ADDENDUM 2

Project: Valley Rd to Bourgault (S25 to S77) Project

Date: 7/25/2025

ALTERNATING 1-LANE, 2-WAY TRAFFIC: FLAGGER-CONTROLLED (45+ MPH HIGHWAYS)

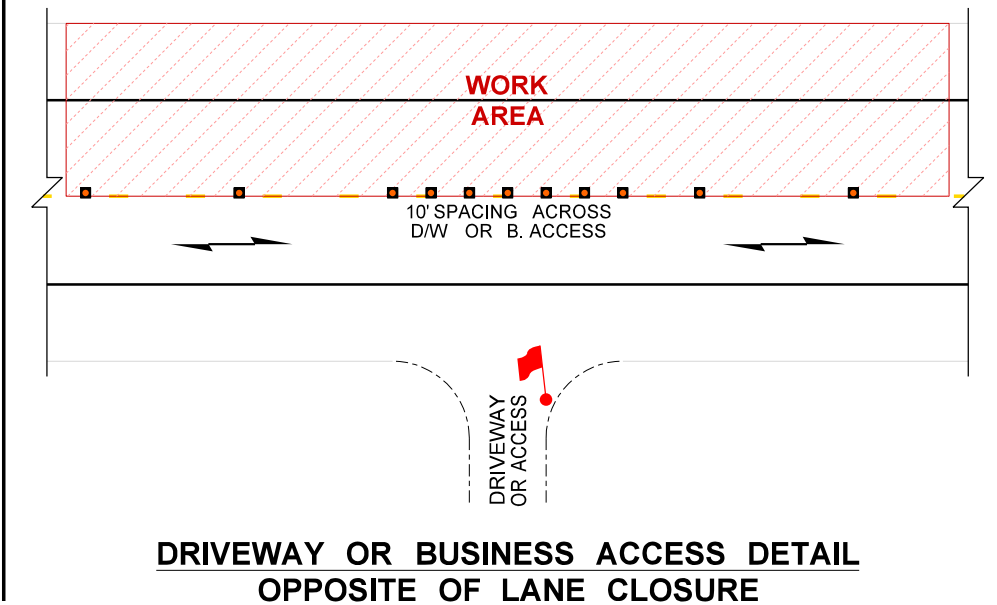
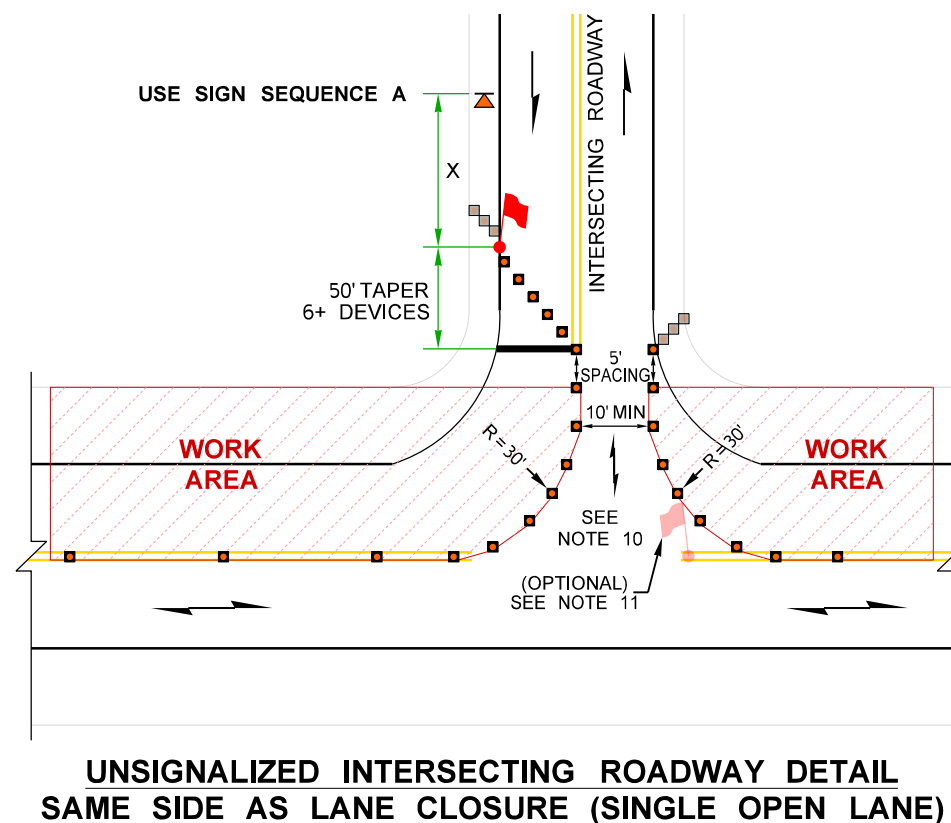
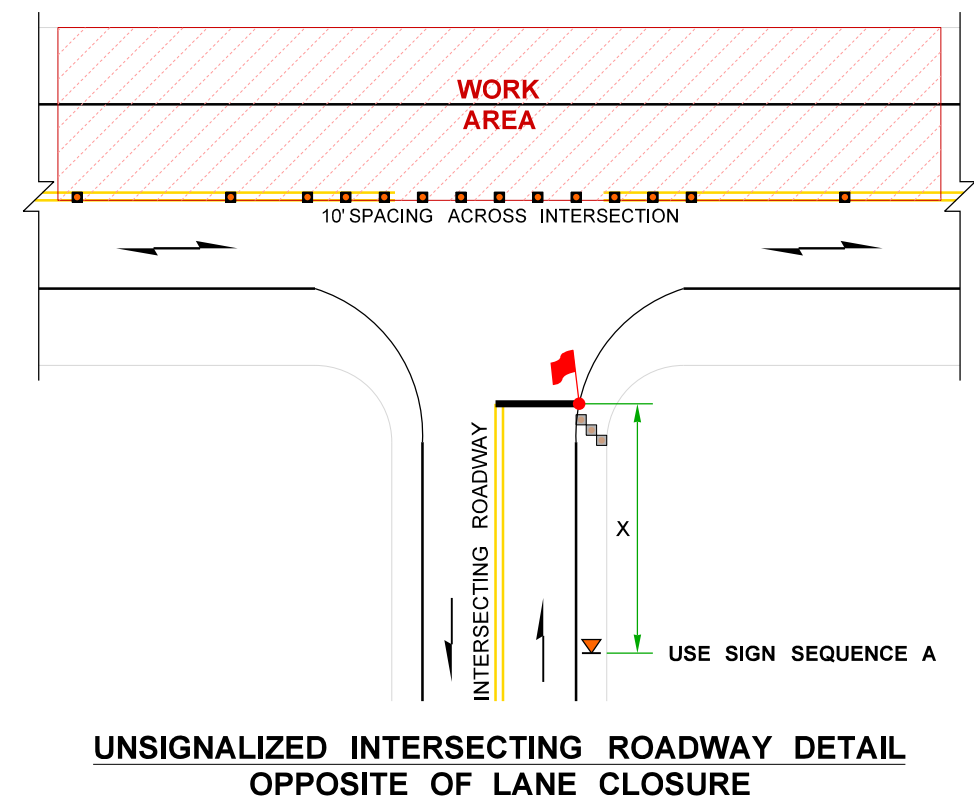
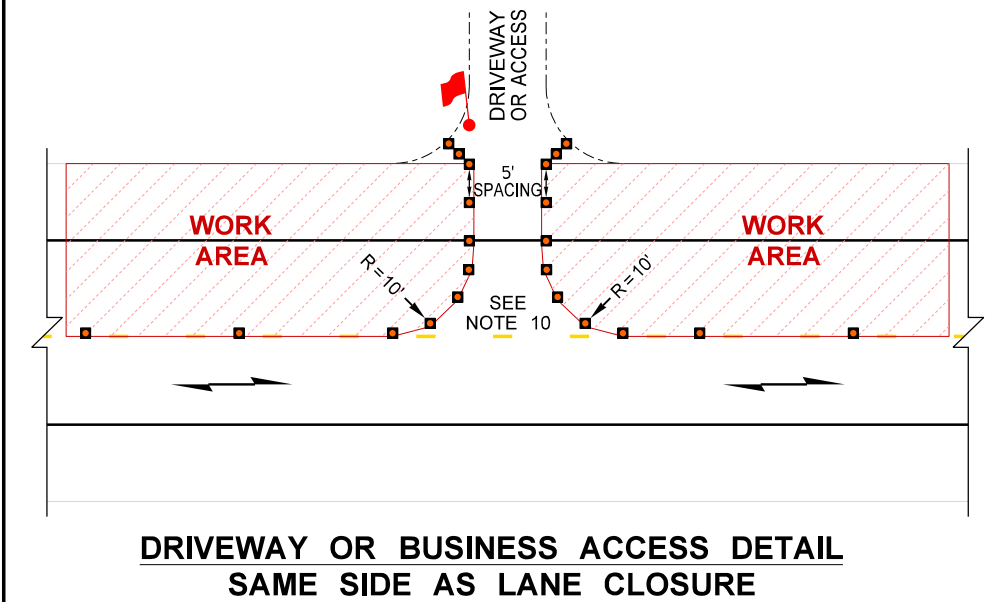
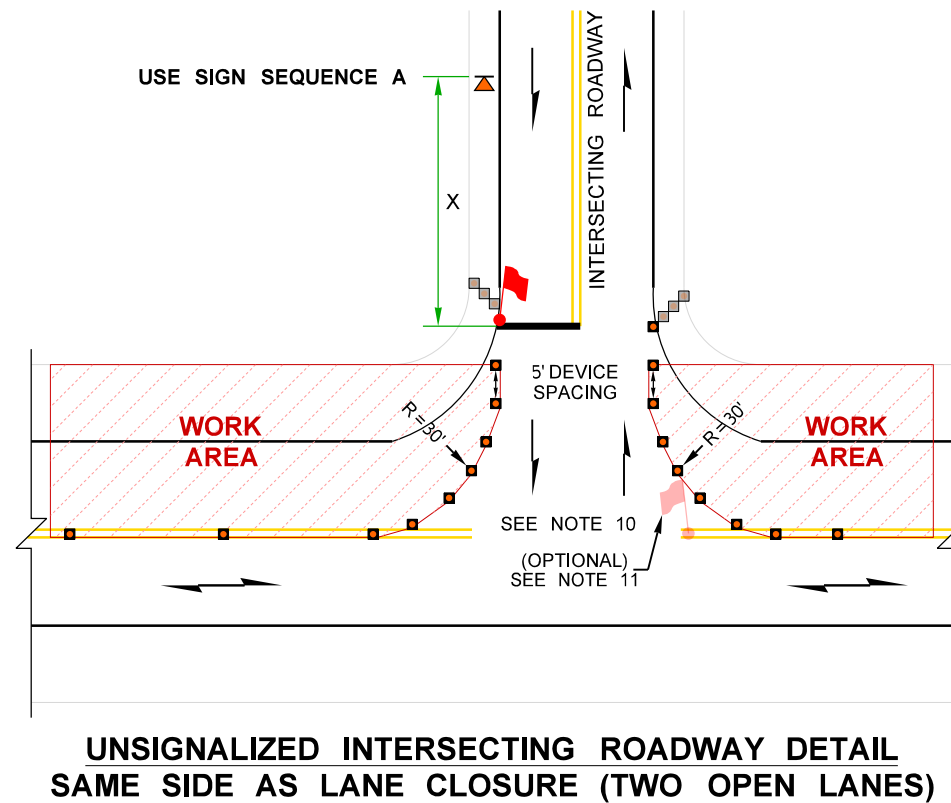
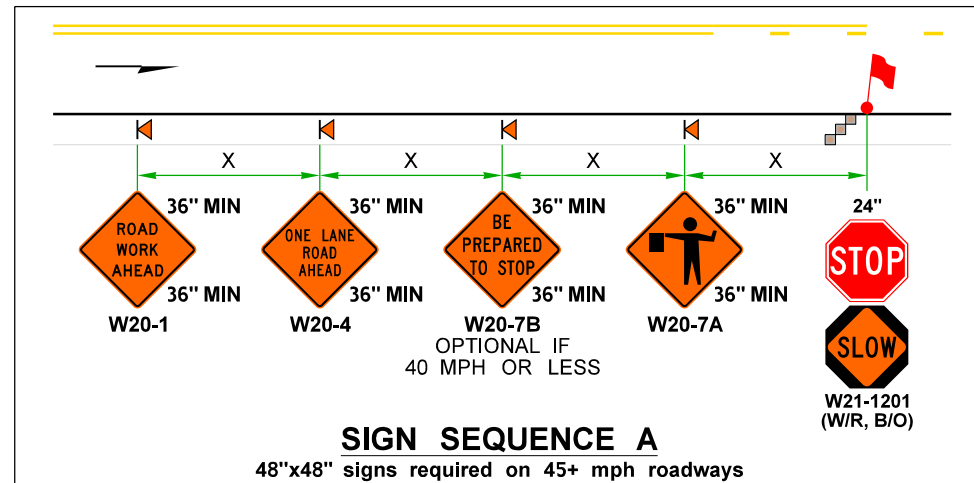
1. Work hours are typical daylight hours. Except for overnight outages per Addendum 1. PUD1 crew works 4 10-hour days M-Th. Contractor will be provided with access to PUD1 laydown yard if access is needed outside of normal crew hours.
2. Traffic Control Plans (TCPs) will be shoulder and 1-lane closure only. See attached.
 - a. No TERO (tribal flagging) required
3. Lane Closure Times:
